Re: Hazardous Waste Management Facility in Pomona, New Jersey EPA Identification No. NJD002325074

Ground Water Sampling and Analysis Plan Revisions

DEP Comments on Groundwater Sampling Work Plans

Ground Water Sampling & Analysis Plan (GWSAP)

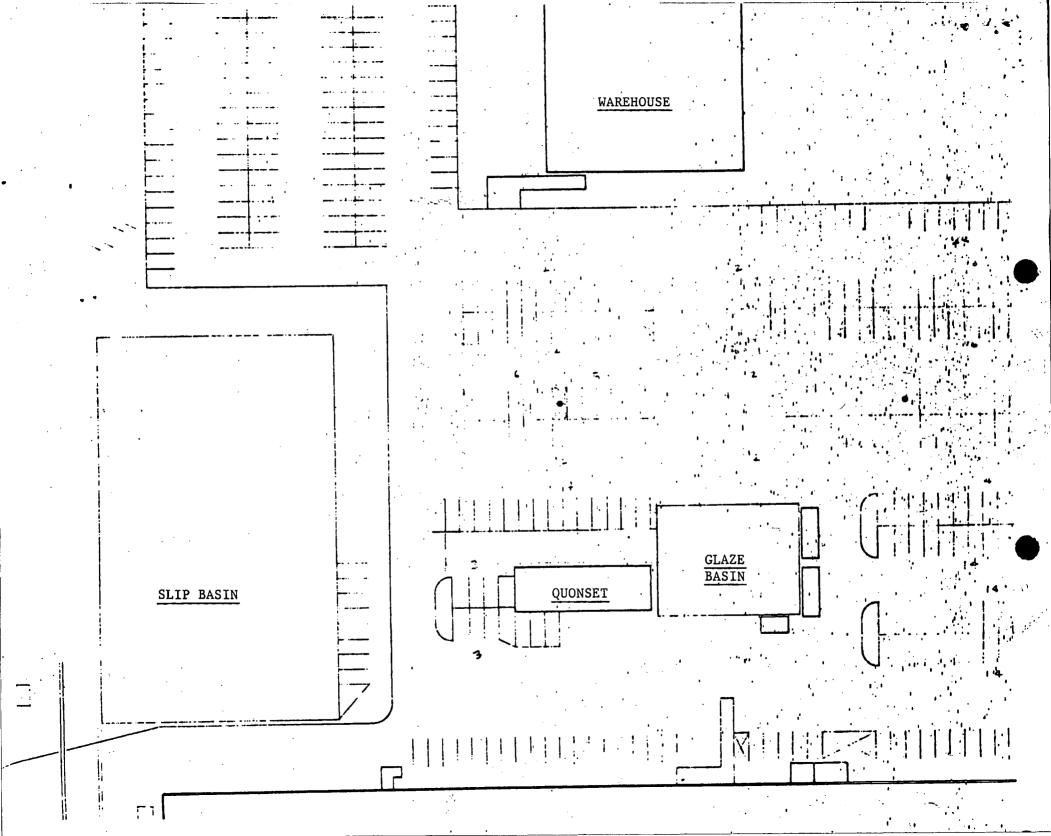
Notes: 1. The glaze is 8" thick at point "A". Therefore the 1 ft. reading is only 4" from the glaze/earth interface.

2. The glaze is 2 ft. thick at point "B". Therefore the 2.5 ft. reading is only 6" from the glaze/earth interface.

3. It was very difficult to take representative samples at points "A" and "B" because of the proximity of the glaze to the test borings.

4. The "l inch From Glaze" sample at Point "B" was taken just below the glaze interface because "white" material was observed.

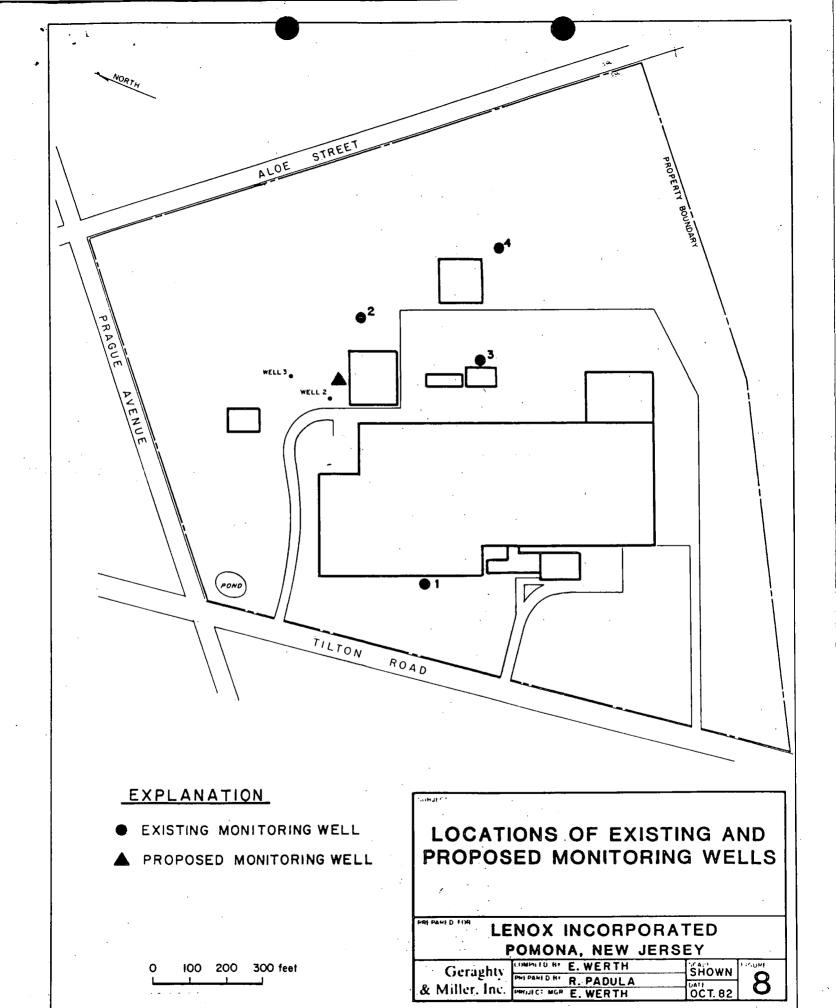
Today, we made the decision to install one more downgradient well, based on the recommendation of Geraghty & Miller, Inc. our consulting groundwater geologists and hydrologists. The proposed location of this well is shown on attached G&M location plan.

This well will be installed on November 22, 1982. The completion of this well will provide a groundwater monitoring system of one upgradient well and three downgradient wells.

GROUNDWATER ELEVATIONS AND GROUNDWATER FLOW AUGUST 11, 1995 - SHALLOW WELLS

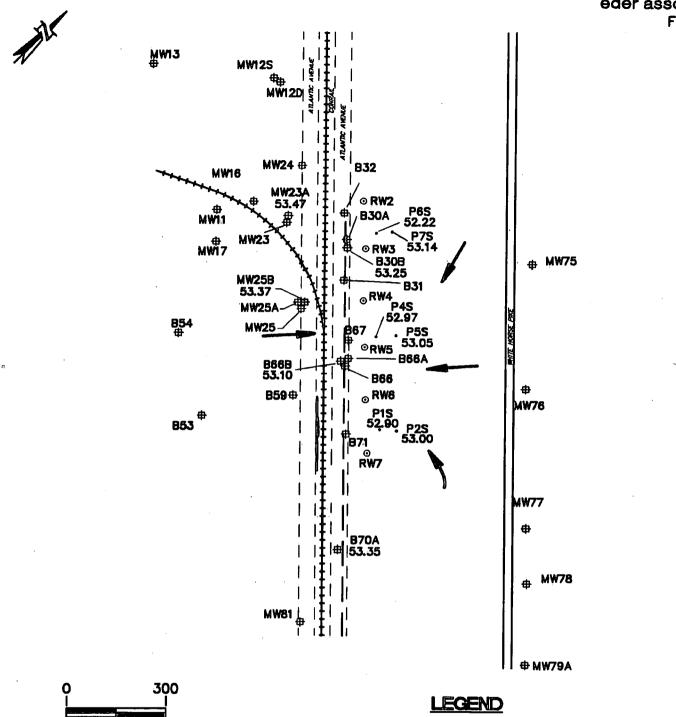
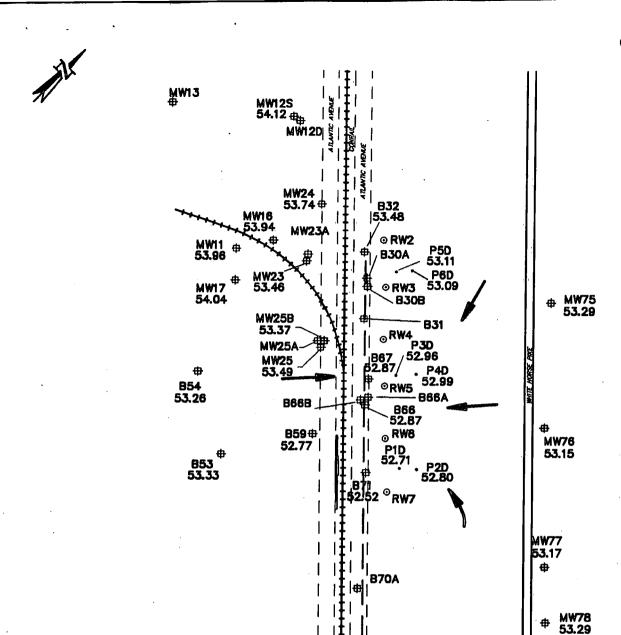
Depth to water measurements were made in the well points and adjacent monitoring wells and piezometers on August 11 with a second round on September 1. The measurements were plotted to develop the groundwater elevation maps shown on Figures 2 to 5. The August and September groundwater elevation data from the shallow and deep well points show that, except for well points 5S, 5D, 6S, and 6D, the zone of influence produced by the extraction system extends to the well point line furthest from the recovery wells. This finding indicates that groundwater flows back toward the recovery system as required by NJDEP. Depth to water data from the White Horse Pike wells show that groundwater elevations along the Pike are higher than the elevations along the recovery well line and that the recovery system produces a zone of influence as far as the White Horse Pike. Although groundwater elevations at well point clusters 5 and 6
